# **Applicant's Response to South Dublin County Council Additional Information Request**

## **P.A.Ref.LRD25A/0003W**

**Woodtown, Ballycullen, Dublin 16**

Prepared on behalf of  
Lagan Homes Ballycullen Ltd

Figure 1 Extract from JFOC Drawing No.23.120.PD2008

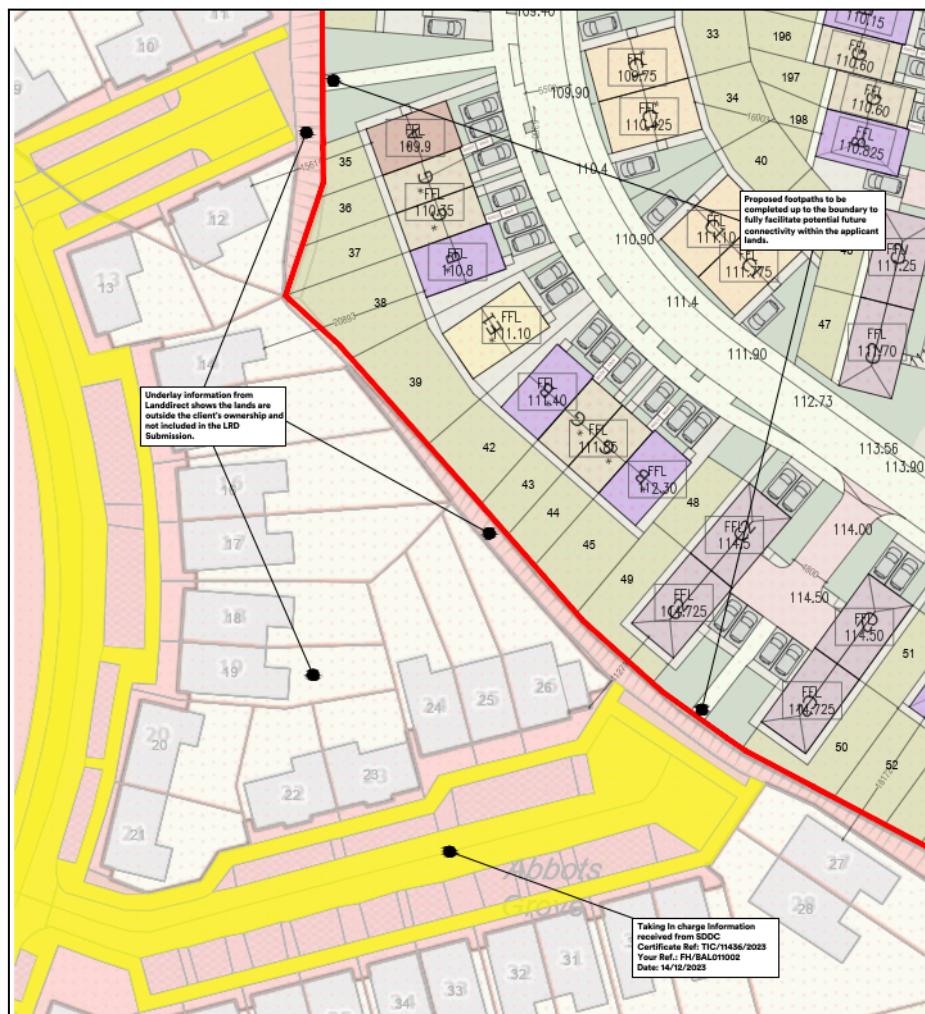
*Notwithstanding the letter submitted by the applicant from its own solicitor, it is advised that the applicant be requested to provide detailed written evidence/ a letter of consent from the owner/receiver of the adjoining Stocking Wood Estate development to confirm that it has right of way across these lands for access and services. Third-party submission is noted in this regard. In particular, written consent is required for any lands within the red line boundary that are not owned by the applicant. Furthermore outside the red line boundary clarity is required in relation to rights of ways the proposals rely on for access. The redline may be amended by way of response to this additional information item, as necessary. The applicant will ensure the avoidance of any ransom strips and that permeability is delivered by showing finished roadways/paths right up to boundaries with adjoining landholding and providing gates to those boundaries in any amended particulars. Any reduction in the number of vehicular entrances into the development should be discussed with the transportation department in advance of responding to this additional information item.*

**Abbots Grove Development:** The original planning application proposed to provide pedestrian/cycle connections to the Abbots Grove development at Abbots Grove Park at the western site boundary. A letter of consent was submitted from South Dublin County Council in this regard as the roads and footpaths have been taken in charge and it was believed a connection could be facilitated. Unfortunately the Abbot's Grove land owners have retained a strip of land behind the footpath and public road as illustrated by figure 1 below which prevents this connection. The applicant attempted to engage with the owner's management company for Abbots Grove in this regard but they were unwilling to enter an agreement for the proposed connections to be provided.

JFOC have prepared a drawing (extract below) to illustrate the land ownership within Abbots Grove and its relationship with the application site incorporating information from Tailte Eireann and South Dublin County Council (Certificate Ref: TIC/11436/2023).

Figure 2 1 in 1 Year Rainfall Event

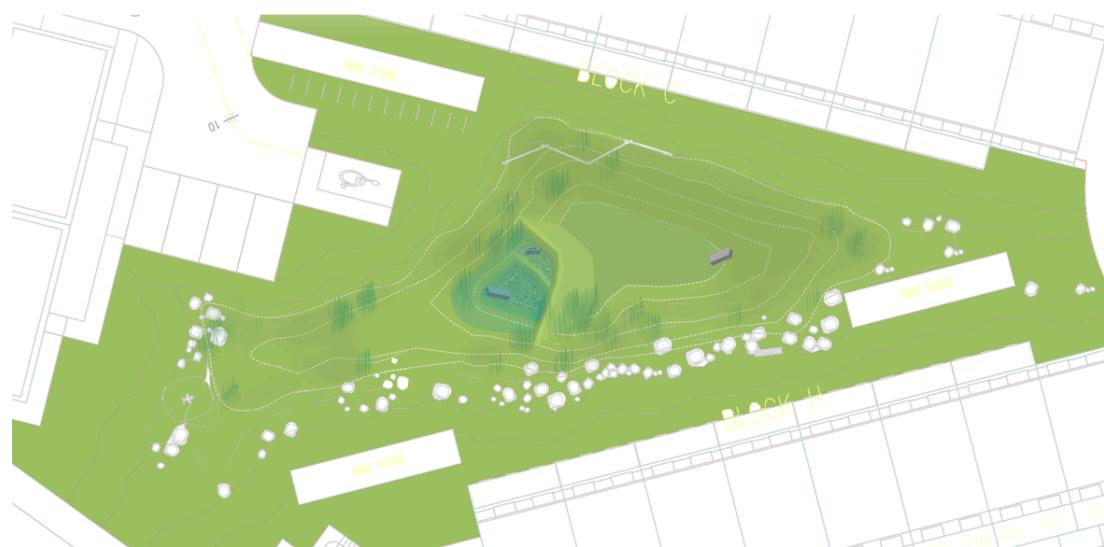
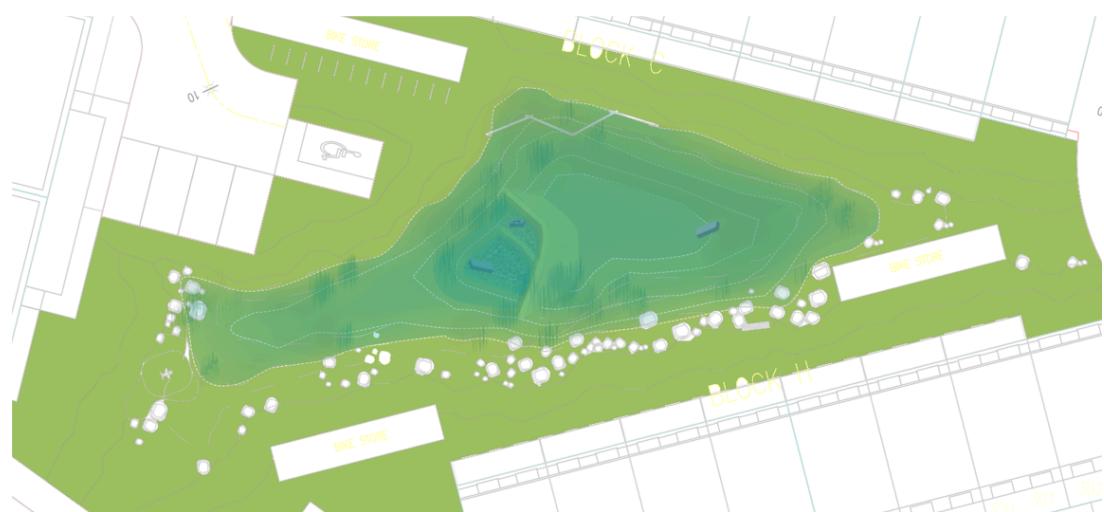
- a) A revised set of landscape and drainage drawings demonstrating how the SUDs is integrated into the open spaces. The design should allow for a functioning open space network and a functioning SUDs drainage network. Landscape plans shall be prepared by a suitably qualified landscape architect following discussions with Public Realm including hard and soft landscaping, levels, sections and elevations, lighting, SUDs design, street tree provision, boundary treatments, play areas and existing green infrastructure assets on site. Plans shall include underground services, proposed lighting, or other features likely to impact on the delivery of the landscape plan as well as all drainage elements in open space areas.*

The introduction of ponds with permanent water levels (500mm) as part of the updated surface water design strategy allows for a greater area of the site to remain free from SuDS infrastructure, increasing the quantity of usability public open space. NMP have designed a network of pedestrian routes across the site that are fully accessible, navigating changes in levels and traversing detention areas even in high rainfall events. NMP drawing 101 clearly identifies the areas of the site that function as public open space and accessible areas in addition to the detention basins and ponds proposed as part of the SUDs drainage network.

On the eastern section of the site, water is held in basins to slow discharge and provide biodiversity. Detention basins in the west of the site are designed pocket parks. These parks exemplify how the design allows for a functioning open space network and a functioning SUDs drainage network. In low storm events water will soak into the ground or be absorbed by vegetation within the detention basin keeping it dry and usable. Rainwater management within the detention basins is illustrated within the Waterman Moylan response statement under separate cover using Detention Basin No. 11 by way of an example. These images are provided in figures 2, 3 & 4 of this Statement.

Figure 6 Detention basin 21 is fully accessible

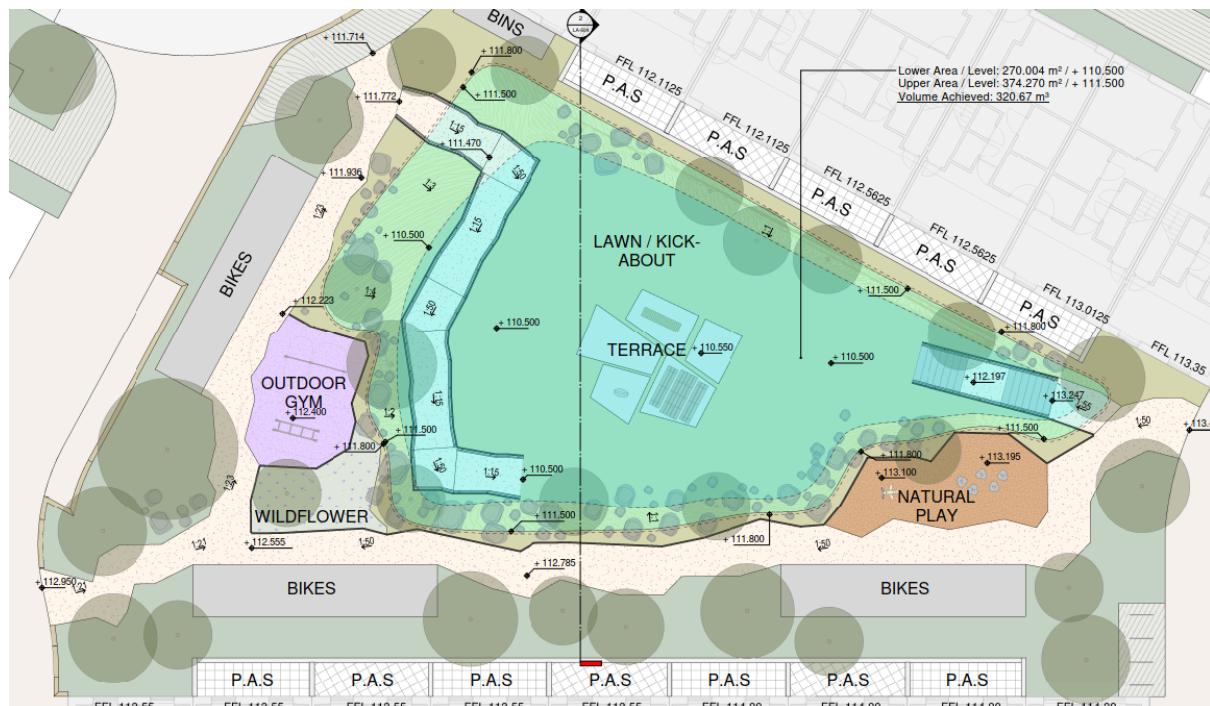
*c) A revised map showing the quantum and differentiating areas of public open space and communal open spaces.*

Taking into consideration the topographical challenges of the site, open space within the proposed development has been considered in terms of its accessibility. As detailed in the cover letter prepared by NMP, the amended site layout plan provides 24.8% of the site as public open space with 16.5% of the open space accessible, including detention basin no.21. These areas provide significant amenity value for residents.

In accordance with the South Dublin County Development Plan, a minimum of 15% of the application site must be provided as public open space. Based on the number and mix of apartments proposed, the 305no. apartments proposed require 2,011sq.m of communal open space. This equates to 15,541.8sq.m of public open space and a total of 17,552.8sq.m when combined with communal open space. As detailed by NMP drawing 101, open space across the site measures 25,746sq.m or 24.8% of the site area.

Figure 8 Extract from JFOC drawing PD1006 - As amended

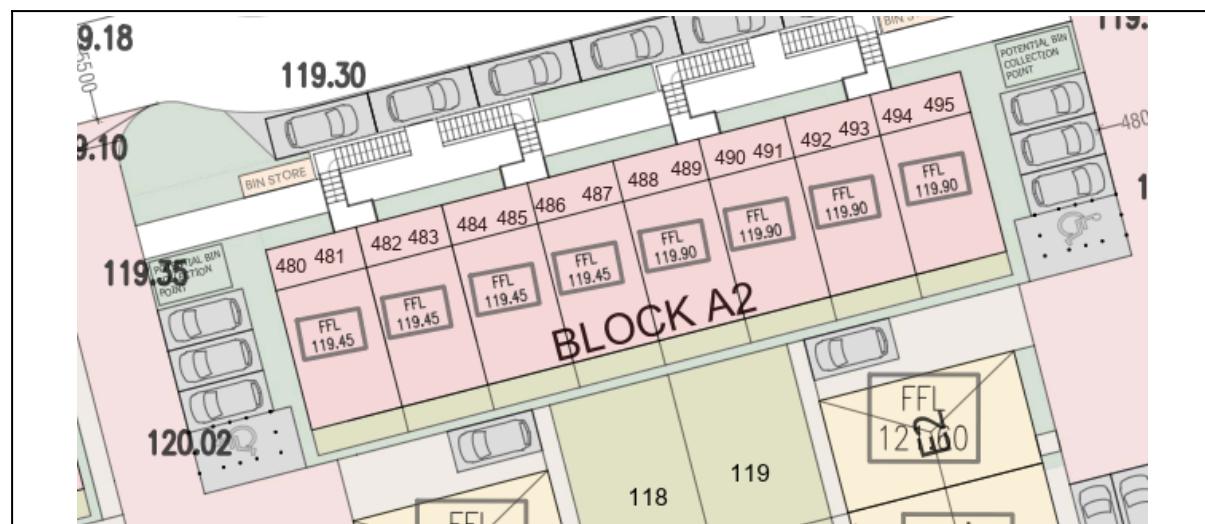
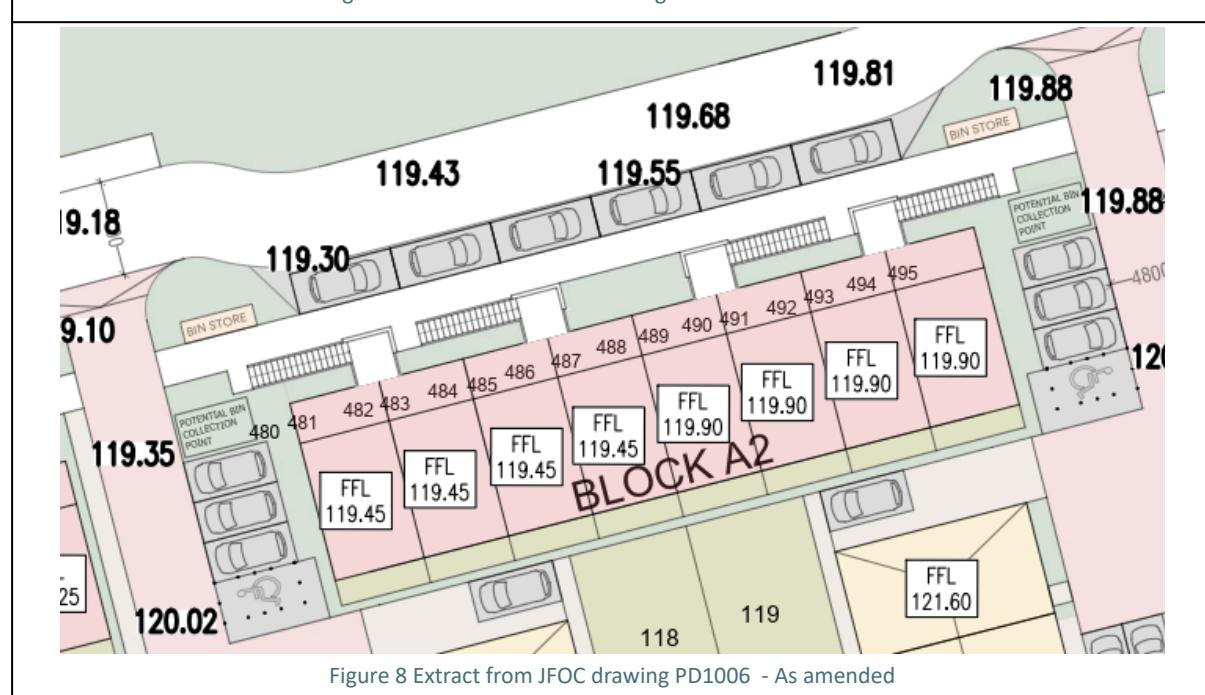
2. *The quality audit feedback form in the RSA shall be signed and an RSA Response Report submitted, outlining how all measures listed in the RSA have been included in the current submission.*

Please note, in response to the RSA submitted with the planning application, the design was amended to ensure the public footpath is outside the external stairs accessing the proposed apartments in all cases (exampled provided below). Please refer to the apartment plans (drawing no. PD4000's) & site layout (drawing no.PD100) by JFOC Architects provided under separate cover. The RSA included with this submission was carried out on the basis of the amended design.
